# HYUNDAI

## Technical Service Bulletin

**26-01-040H-1**

**SUBJECT:** INSIDE REAR COMBINATION LAMP ASSEMBLY INSPECTION – REPLACEMENT OR WASHER INSTALLATION (LIMITED COVERAGE CAMPAIGN LA19)

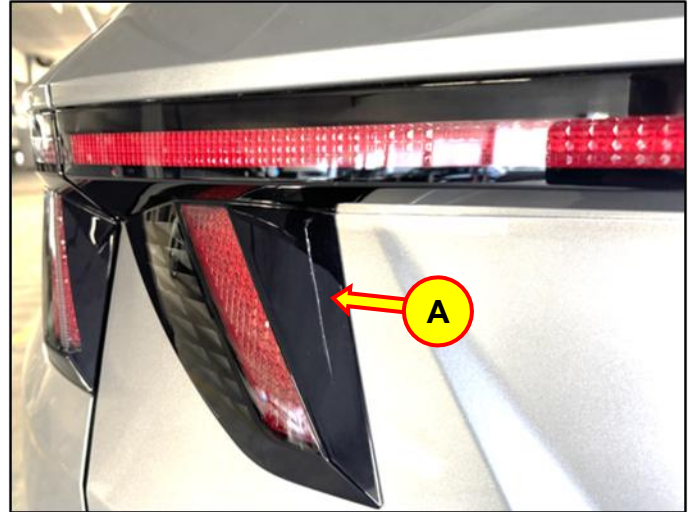
1. Visually inspect the LH side of the removed inside rear combination lamp assembly for a crack (A).

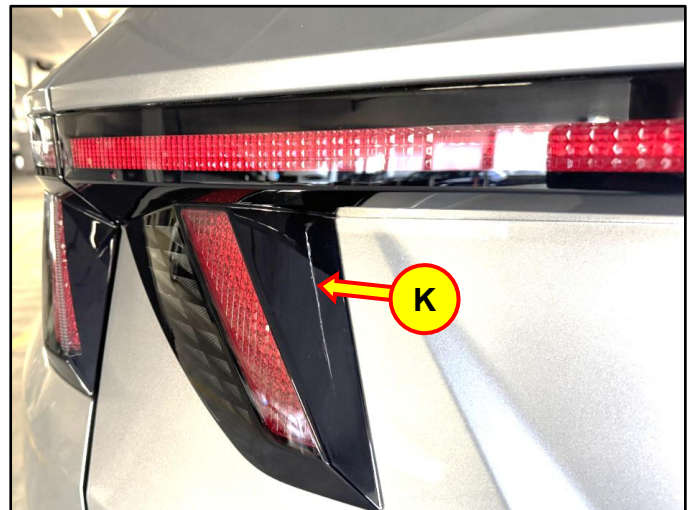
12. If the inside rear combination lamp assembly is cracked (K), then proceed to the [Inside Rear Combination Lamp Assembly Replacement](#) procedure.

If the inside rear combination lamp assembly is intact, then proceed to the [Washer Installation](#) procedure.

**Washer Installation**

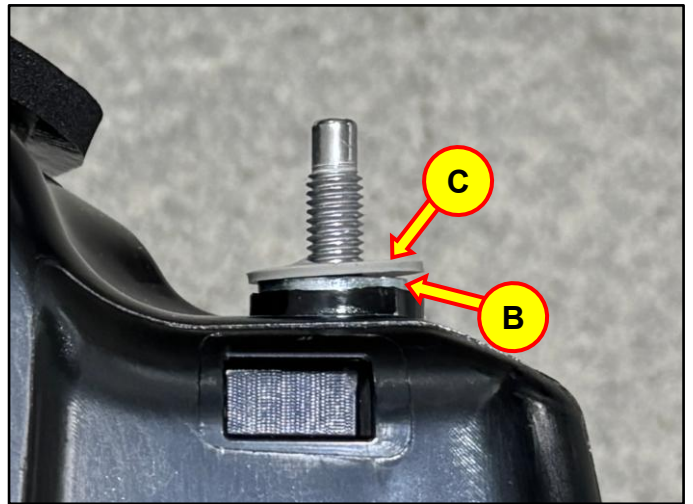
1. Remove the **2** rubber gaskets from the top and bottom studs (A) of the LH side of the inside rear combination lamp assembly.

2. On each stud, install the supplied metal washer (B) first, then replace the rubber gasket (C).

The metal washers **MUST** be installed before the rubber gaskets. Installing the metal washers after the rubber gaskets may damage the tailgate body and may **NOT** provide an adequate seal, potentially leading to water ingress into the tailgate panel.
